Park Hamilton Condominiums

STAFF REPORT
CITY OF BEVERLY HILLS

**For the Architectural Commission
Meeting of March 17, 2010**

SUBJECT: **PL 1005705 - Park Hamilton Condominiums**
225 South Hamilton Drive
Modifications to a previously approved condominium project

Approved Design

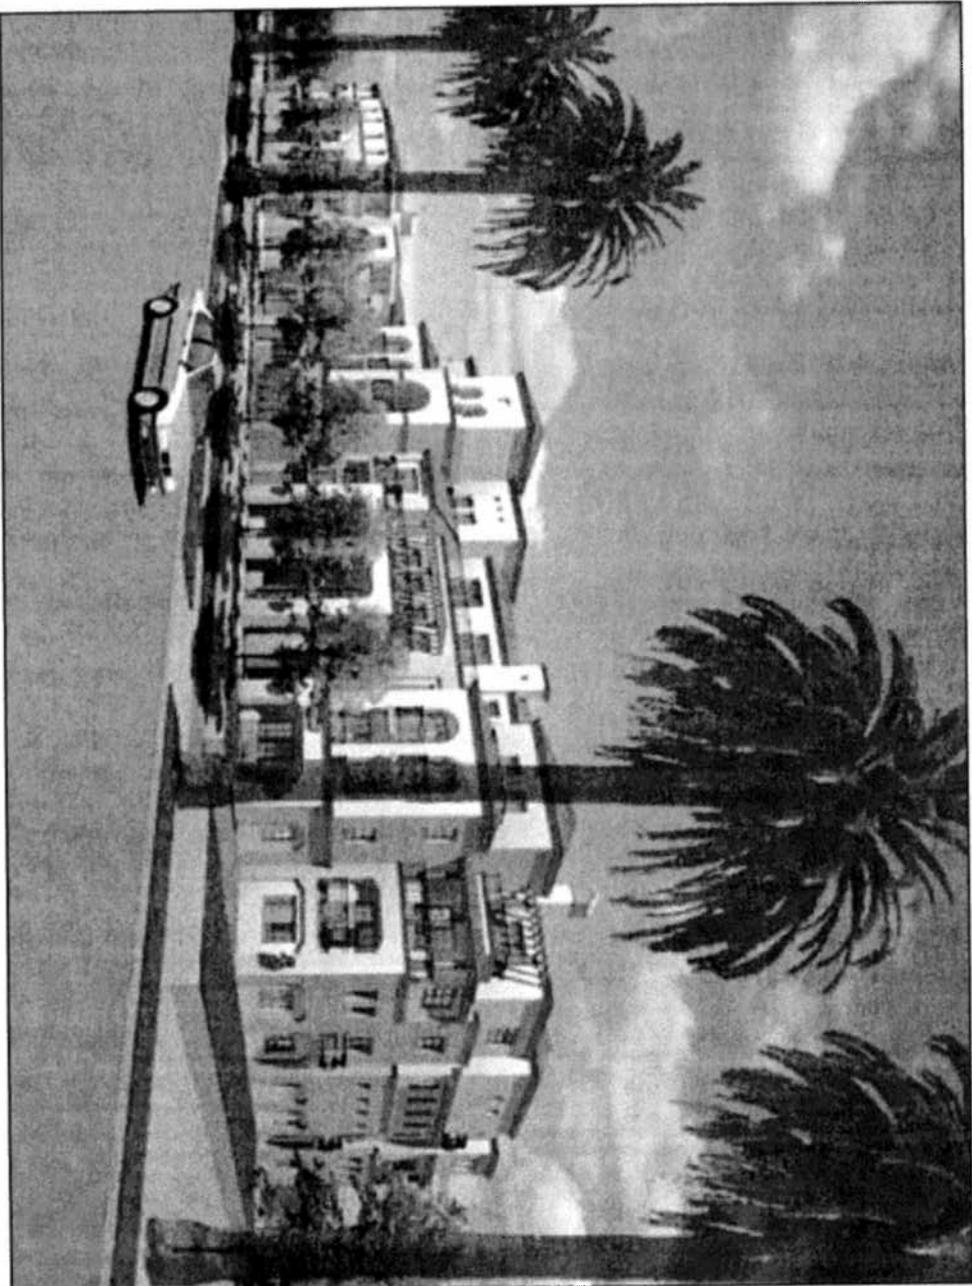
- 1. Windows:** The original project was approved with divided-light vinyl windows. The applicant proposes to install divided-light wood frame windows with aluminum cladding manufactured by Kolbe.

The proposed windows appear to be of high quality and are consistent with the architectural style of the building. Replacing the vinyl windows with aluminum clad wood

- 2. Building Entry:** The project consists of two buildings that are separated by a courtyard, and the original approval called for an entry to each building to be located along South Hamilton Drive. The revised proposal maintains the North Hamilton Drive entry on the southernmost building, but eliminates the North Hamilton Drive entry from the northernmost building. To replace the entry on the northernmost building, the applicant proposes to install a gated entry with signage at the courtyard between the two buildings. The courtyard entry would then lead to a building entrance located within the courtyard. The gate is constructed of 8'4" tall wrought iron, and the proposed signage is located above the top of the gate with a maximum height of 10'7". Additionally, the proposed gates are set back approximately 30' from the front property line. The proposed signage consists of cast metal letters on a painted metal background.

Removal of the previously approved entry does not appear to materially change the appearance of the northernmost building. Historically, the Commission's desire has been to maintain a prominent entry to multi-family developments. Although the proposed building entry is no longer located at the front of the building, the gated courtyard design appears to create a prominent entry point that is readily visible from the street. Additionally, the gated entry provides security for the courtyard and condominium units. Because the proposed design creates an easily identifiable entry and is compatible with the building design staff supports this change. However, the gated entry may be larger in scale than is necessary, and the Commission may wish to discuss whether the sizing is appropriate.

- 3. Landscaping:** The original plan included landscaping and a fountain at the entry to the courtyard between the two buildings. The landscaping received preliminary approval, but was required to be returned to the Commission for review prior to planting. The applicant never returned to the Commission for final approval, and because of this the new owner is seeking approval of a landscaping plan. The new plan eliminates the fountain, and instead provides a realigned walkway to the courtyard entry gate as outlined above. Because final approval was never granted for the landscape plan, this plan should be reviewed as new.

The proposed landscape plan appears to be consistent with the architectural style of the project, and will be a compatible addition to the neighborhood; however, the proposed trees appear to smaller in size (24" box and 15 gallon) and will not be compatible with the large scale of the project at the time of planting. Because of this staff supports the landscape plan with the incorporation of conditions to require more mature landscaping at the time of planting. The specific sizes are outlined in the recommended conditions of approval below.

1. All trees identified as "24" box" on the submitted landscape plan shall be increased in size to a 48" box.
2. All trees identified as "15 gallon" on the submitted landscape plan shall be increased in size to a 24" box.
